Interactive comment on “Application of an O-ring pinch device as a constant pressure inlet (CPI) for airborne sampling” by Sergej Molleker et al.

Sergej Molleker et al.

Received and published: 20 May 2020

Fig. 1. Figure 7

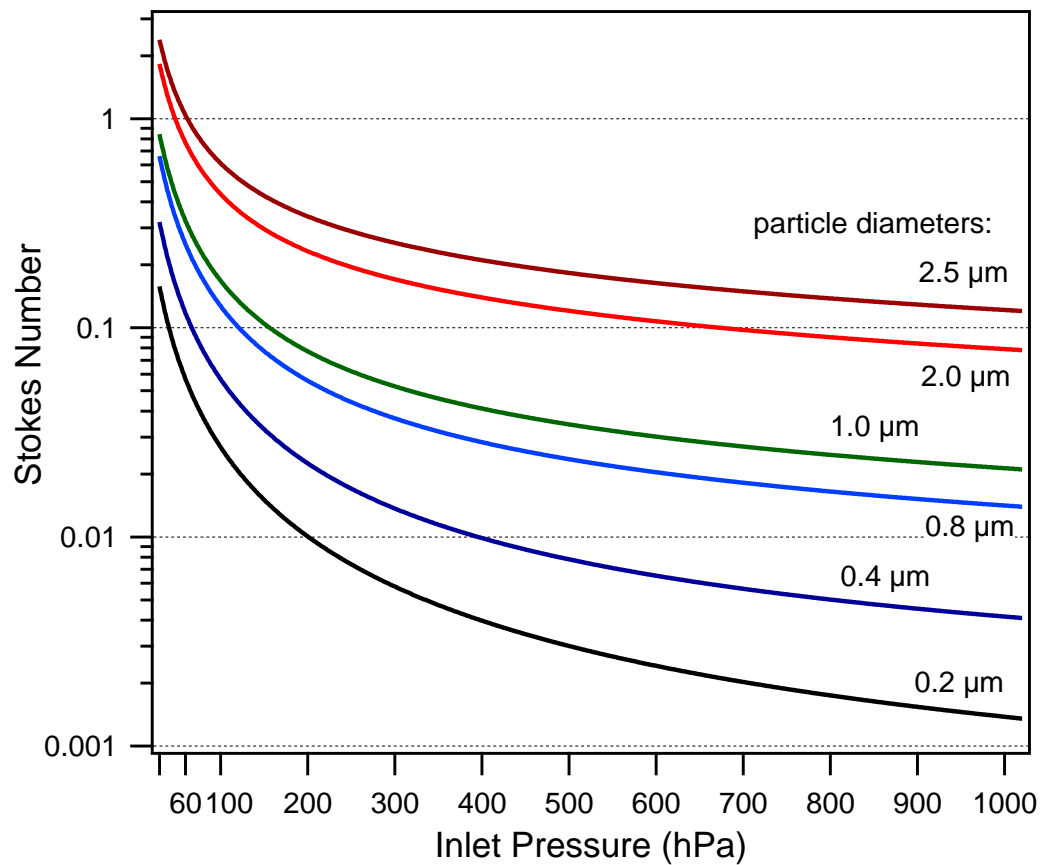
Figure 1: Typo in "constant pressure inlet" Figure 7: the mixed use of color and line style is not very intuitive as only one parameter is varied here. Consider, e.g., using the same line style while labeling each line in the plot.

Corrected.
